Appendix4-4 Review of Layout Plan Provided by KUTC and PR

(1) Review of Station plan in RAP Report

(2) Review of Drawings Prepared by PR

Figure 13 PR Drawings Review (Tower Station)

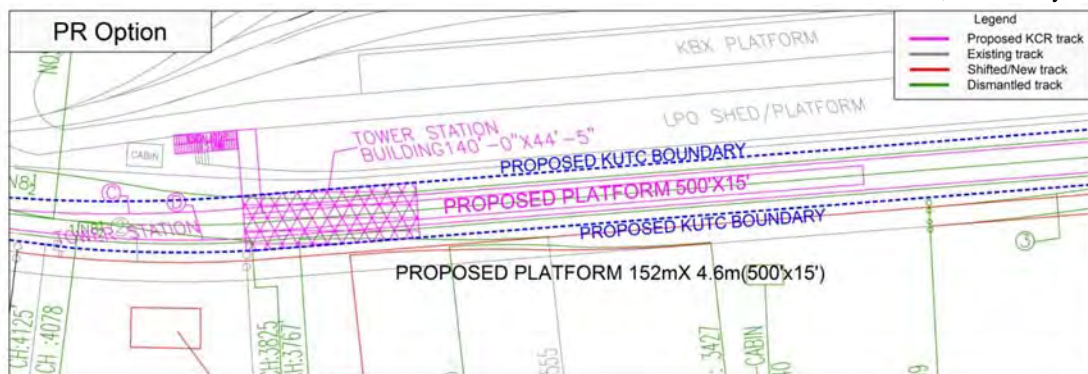
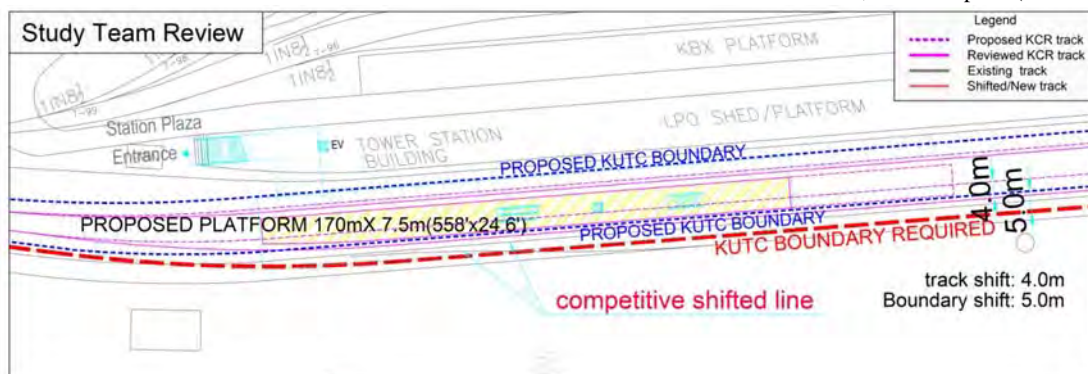
Station	Review
Tower	Land shortage as PR planned insufficient platform width
Karachi City	Land shortage as PR planned insufficient platform width
DCOS	Platform width to be modified
Karachi Cantt.	To be finalized based on site survey
Naval	To be finalized based on site survey
Chanesar	KCR facilities be out of proposed boundary
Shaheed-e-Millat	To be finalized based on site survey
Karsaz Halt	KCR facilities be out of proposed boundary
Drigh Road	To be finalized based on the site survey
